SUBJECT: OCONEE NUCLEAR STATION, UNITS 1, 2, AND 3 - STAFF ASSESSMENT OF INFORMATION PROVIDED PURSUANT TO TITLE 10 OF THE *CODE OF FEDERAL REGULATIONS* PART 50, SECTION 50.54(f), SEISMIC HAZARD REEVALUATIONS FOR RECOMMENDATION 2.1 OF THE NEAR-TERM TASK FORCE REVIEW OF INSIGHTS FROM THE FUKUSHIMA DAI-ICHI ACCIDENT (TAC NOS. MF3736, MF3737, AND MF3738)

STAFF ASSESSMENT BY THE OFFICE OF NUCLEAR REACTOR REGULATION

RELATED TO SEISMIC HAZARD AND SCREENING REPORT

OCONEE NUCLEAR STATION, UNIT NOS. 1, 2, AND 3

Figure 3.2-1 Plot Comparing the Staff's and the Licensee's Mean Control Point Hazard Curves at a Variety of Frequencies for the Oconee Site. RAI Response Curves are Licensee Curves Developed using the Currently Endorsed CEUS-SSC (NUREG-2115) for the Oconee Site

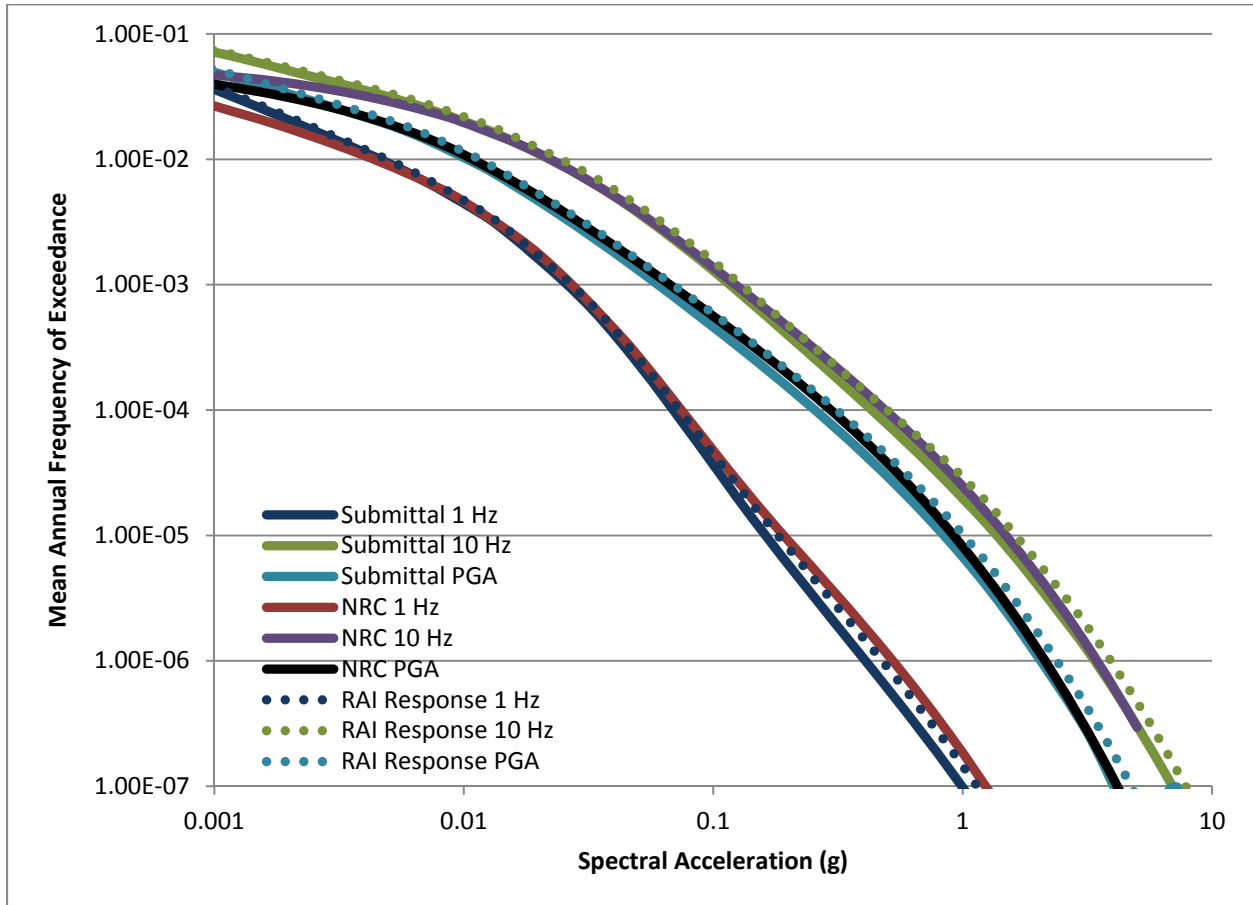
As part of its RAI response, the licensee provided base rock hazard curves in order to show the impact of its refinements to the CEUS-SSC seismicity catalog. Figure 3.2-1 of this assessment shows the licensee's base rock hazard curves along the staff's base rock hazard curves. As shown in Figure 3.2-1 of this assessment, the impact of the licensee's changes to the hazard inputs have a very minor impact on the hazard for the Oconee site.

Figure 3.3-1 Plot of Staff's and Licensee's Base Case Shear-Wave Velocity Profiles for the Ocone site

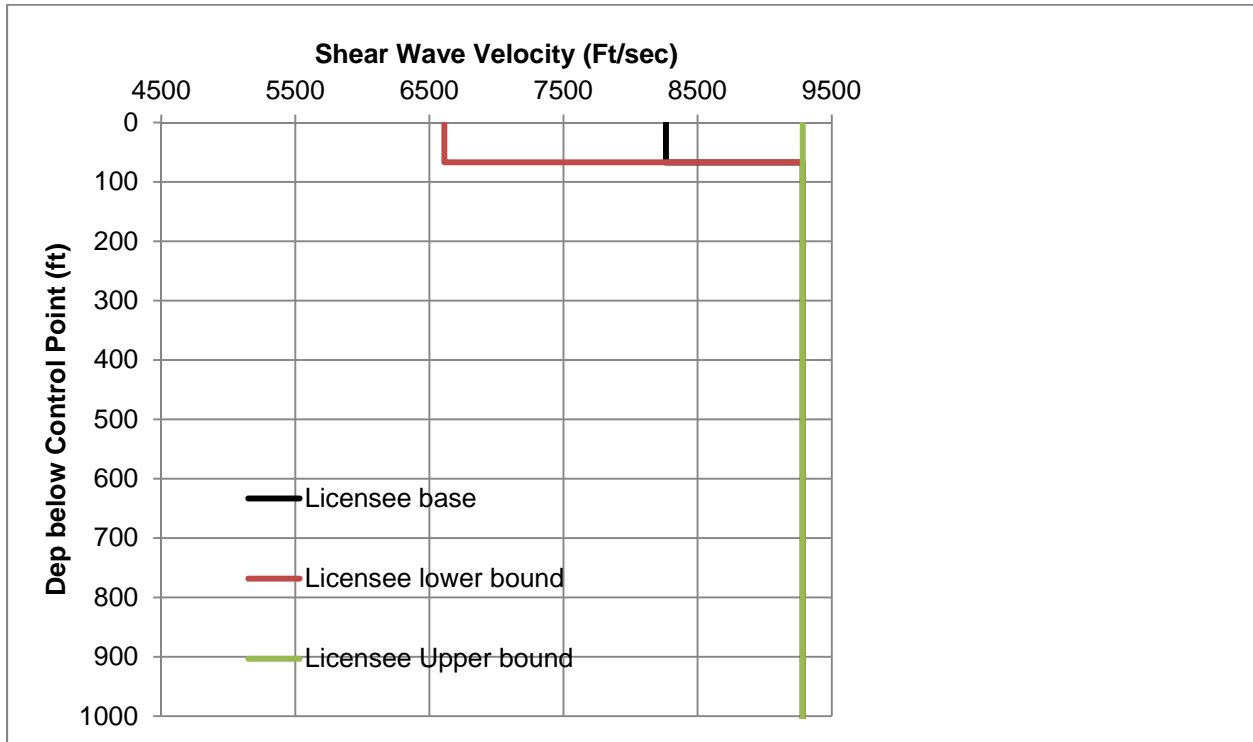
To characterize the subsurface geology, the licensee developed three site base case profiles. The licensee's middle, or best estimate profile was developed using measured the shear-wave velocity of 8,265 fps [2,519 m/sec] from the MSIV project and assumed to be constant over the 67 ft [20.4 m] of firm rock. The licensee developed upper and lower base case profiles using a natural log standard deviation of 0.20. As such, the lower velocity profile has a constant S-wave velocity of 6,612 fps [2,015 m/sec] and since the S-wave velocity for the upper velocity profile exceeds the assumed base rock velocity of 9,285 fps [2,830 m/sec], the licensee concluded that the upper profile should be considered as hard base rock. Figure 3.3-1 of this assessment shows the licensee's three shear-wave velocity base case profiles.

The licensee used the latest geotechnical exploration data to establish the shear wave velocity profile for the site, which was based on three boreholes with shear wave velocity measurements (P-S logging) at the distance between 19.5 and 28 ft [5.9 to 8.5 m] to the edge of the three reactor units. Because the site profile established based on some recent obtained and site-specific data and is fairly well characterized, the NRC staff used the same input velocity profiles as those provided by the licensee. Figure 3.3-1 of this staff assessment shows the velocity profiles used by the licensee and the staff.

Figure 3.3- 2 Plot Comparing the Staff's and the License's Median Amplification Functions and Uncertainties for two input loading levels for the Oconee site

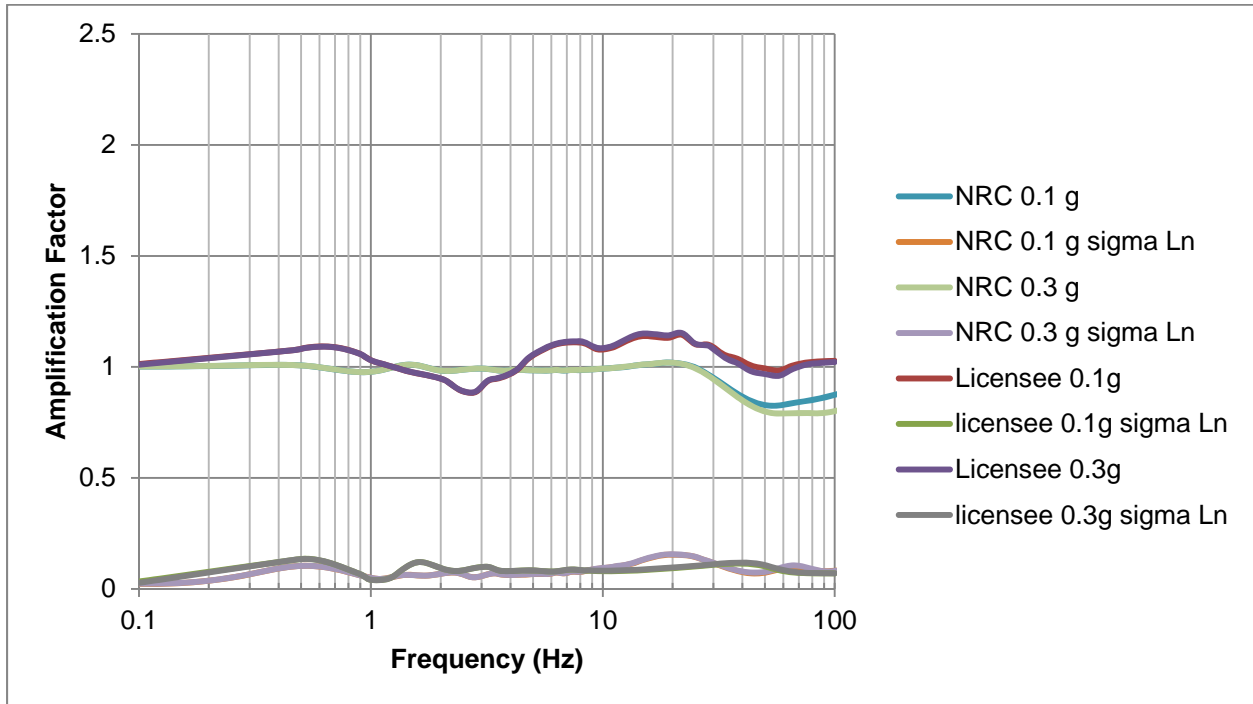
Figure 3.3-2 of this assessment shows a comparison of the staff's and licensee's median site amplification functions and uncertainties (± 1 standard deviation) for 2 of the 11 input loading

levels. Due to the use of very low damping values and modeling of the rock behavior as essentially linear for the range of input loading levels, the NRC staff's confirmatory amplification factors are essentially one for the entire frequency range. The licensee's amplification functions are also flat over the entire frequency range for the two loading levels shown in the SHSR.

Figure 3.3-3 Plot Comparing the Staff's and the Licensee's Mean Control Point Hazard Curves at a Variety of Frequencies for the Oconee site

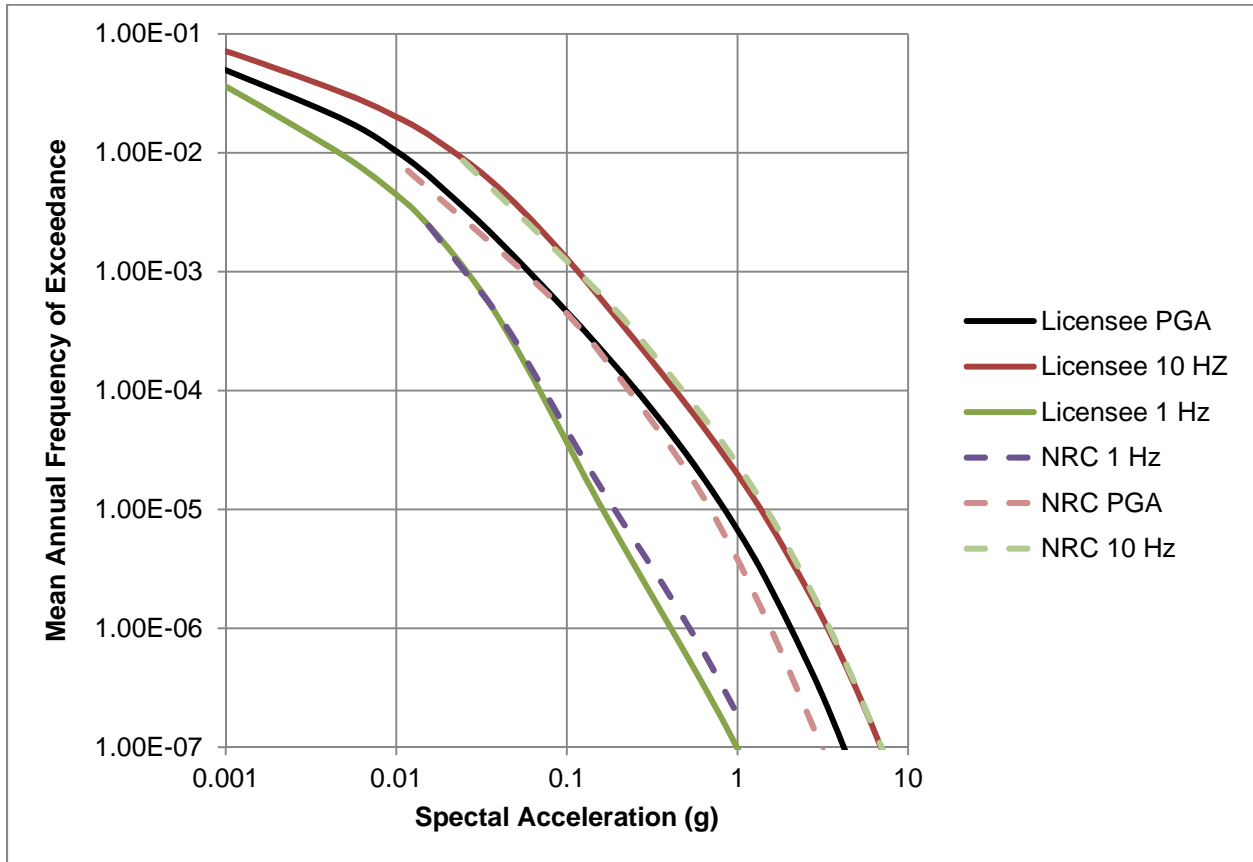
Overall, the licensee's approach to modeling the subsurface rock properties and their uncertainty, results in very similar amplification factors as those developed by the staff. In addition, as shown in Figure 3.3-3 of this assessment, the NRC staff's and licensee's control point seismic hazard curves are very similar.

Figure 3.4-1 Comparison of the Staff's GMRS with Licensee's GMRS and the SSE for the Oconee site

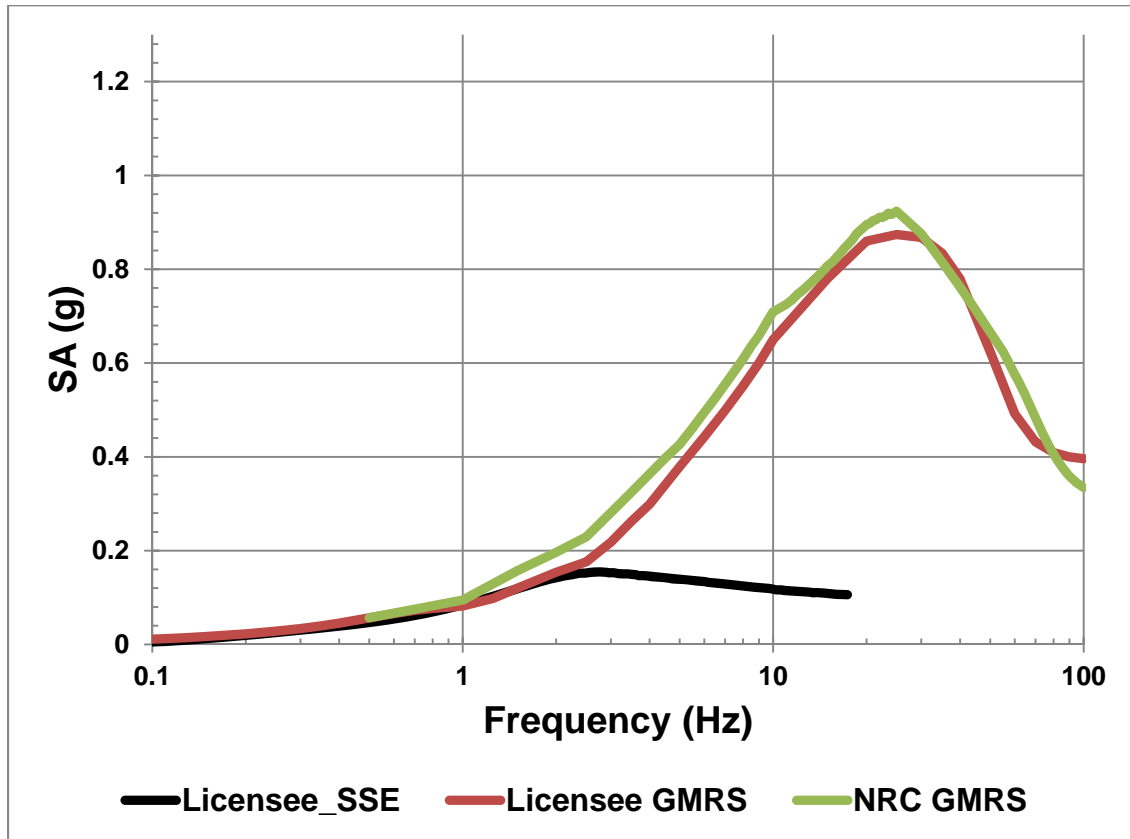
The NRC staff independently calculated the 10^{-4} and 10^{-5} UHRs using the results of its confirmatory PSHA and site response analyses, as described in Sections 3.2 and 3.3 of this staff assessment, respectively. Figure 3.4-1 of this assessment shows a comparison of the GMRS determined by the licensee to that determined by the NRC staff.

The NRC staff confirms that the licensee used the present-day guidance and methodology outlined in RG 1.208 and the SPID to calculate the horizontal GMRS, as requested in the 50.54(f) letter. The NRC staff performed both a PSHA and site response confirmatory analysis and achieved results consistent with the licensee's horizontal GMRS. As such, the NRC staff concludes that the GMRS determined by the licensee adequately characterizes the reevaluated hazard for the Oconee site. Therefore, this GMRS is suitable for use in subsequent evaluations and confirmations, as needed, for the response to the 50.54(f) letter.
